Re: FPL Manatee Plant Proposed Burner Change,
FPL letter 10/22/99 and DEP letter in response 11/1/99

Re: FPL –Manatee Plant
Proposed Burner Change-out
Response to Manatee Burner Replacement

Re: FPL Manatee Plant
Proposed Burner Change-out

**Martin FL Units HRSG3A, 3B, 4A, 4B, PMR1-PMR2
1997 NO_x Emission Rate**

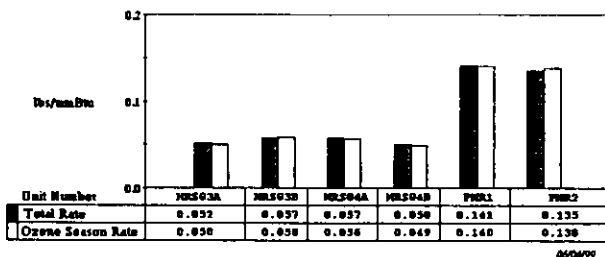
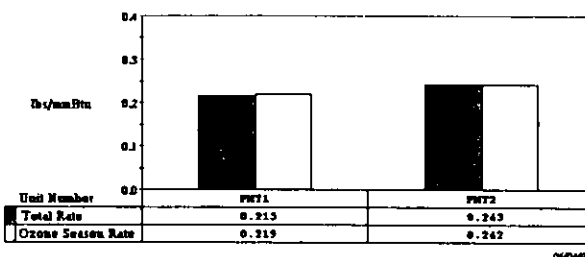
The following figures indicate that NO_x emissions are indeed substantially lower at the 863 MW Martin Plant units (PMR 1 and 2) than the Manatee units. Please advise if the lower emissions are actually believed to be the result of the LNBs alone or in conjunction with the dual-fuel capability.

The lower Martin Plant NOx emissions are not the result of low NOx burners alone, but in conjunction with the dual-fuel capability.

**Manatee FL Units PMT1-PMT2
1997 Heat Input**

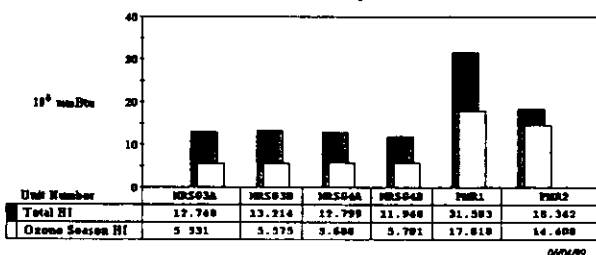
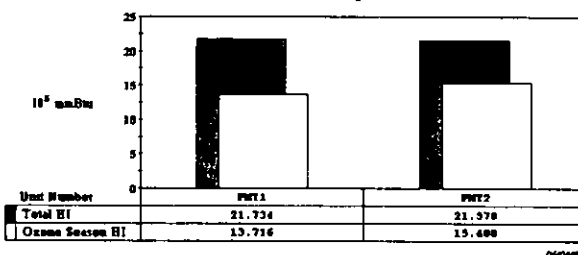
The following figures indicate that the total annual heat input is greater for the two 863 MW Martin Plant units than for the virtually-identical Manatee Plant units. Please provide a brief explanation and advise if the change to mechanical atomization will substantially affect the relative use of the Manatee units with respect to the 863 MW Martin units.

The relative differences in heat input from Martin Plant 863 MW units and Manatee Plant 863 MW units are primarily due to differences in utilization based on dispatch requirements. The Martin and Manatee Plant four 863 MW units are dispatched based on fuel economics. Fuel market fluctuations between natural gas and fuel oil will dictate which units run first and longest. The change to mechanical atomization will effect no change in the dispatch order of these units and consequently on their relative use.

Figure 1 – CSL Twin Register Low NOx Burner Details

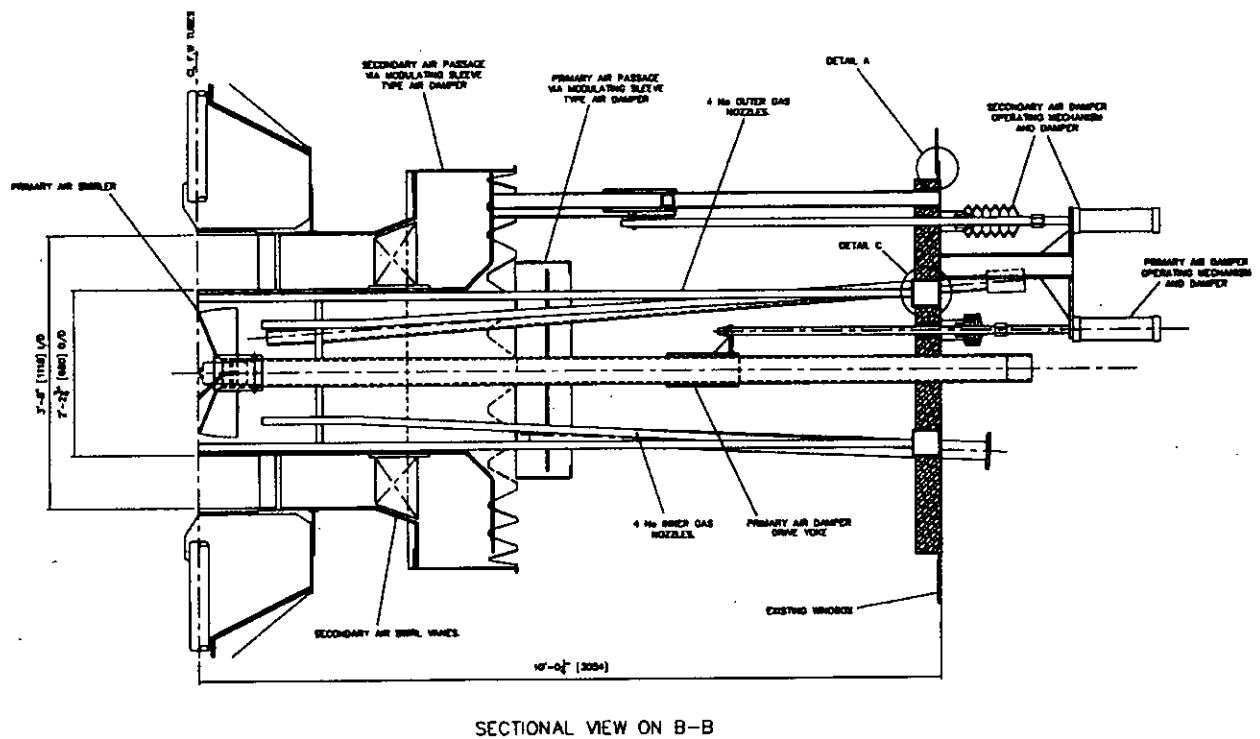
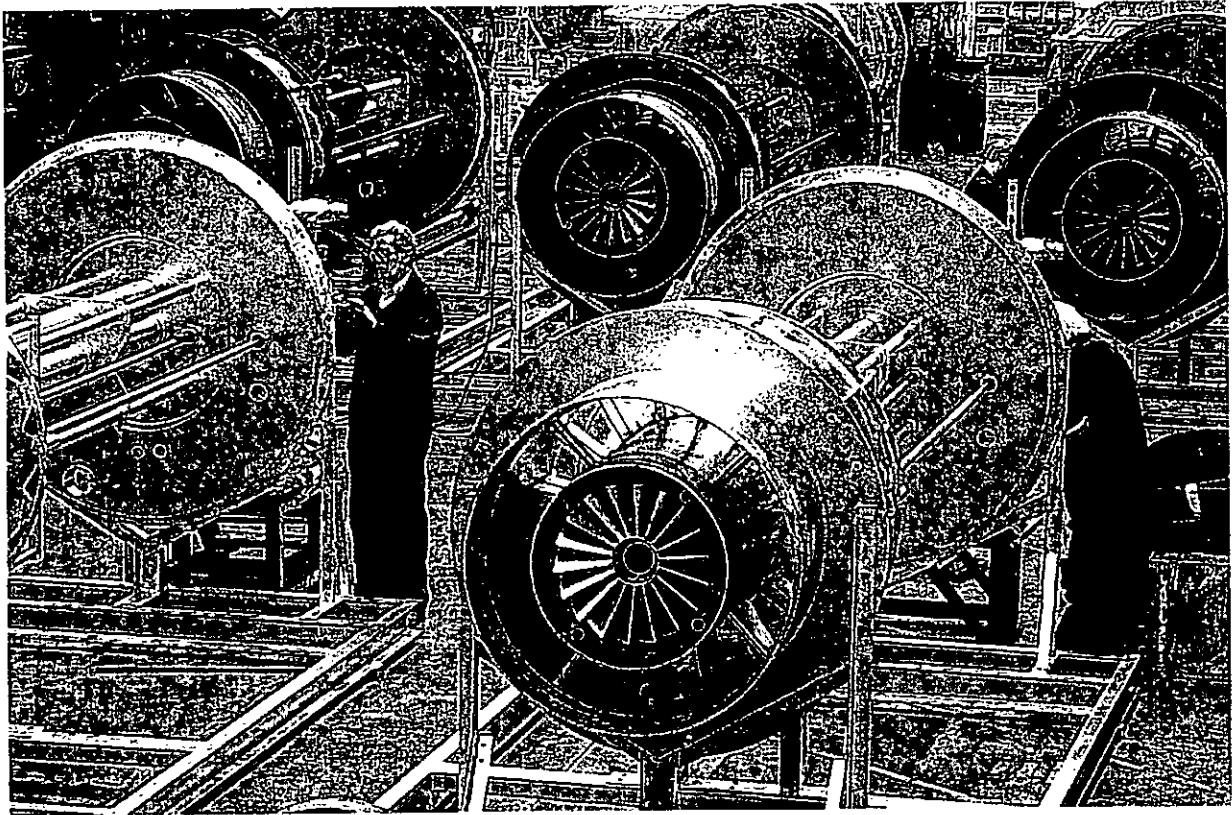
1. The type, model number, diagram, and characteristics of the proposed burners. This should describe how air and fuel are introduced and staged to minimize emissions.
2. Similar information regarding the actual mechanical atomizer. Include fuel pressure, operating ranges, and other typical characteristics. Advise if there will still be some steam-mechanical atomization at low load and low temperature.
3. An explanation of the manner by which emissions of carbon monoxide, particulate matter, nitrogen oxides, and visible emissions (including acid smut) are all simultaneously reduced.
4. Describe emissions impacts at low load.

The proposed burner is **CSL Low NOx Twin Register type**. This burner will be dual register design with separate sleeve type air dampers for the inner (primary) and outer (secondary) air passages (see Figure 1)

The principal of staging air and fuel in reducing NOx levels is well documented, and the associated design features are incorporated on the air side and fuel side of the burners. The air staging is accomplished by the dual register (two-zone) design, which partitions the air into two distinct regions with different flow and swirl characteristics. The fuel staging is accomplished by the design of the fuel oil atomizer tip, which develops fuel lean and fuel rich zones of atomized fuel oil into a number of flame regions, as shown in Figure 2.
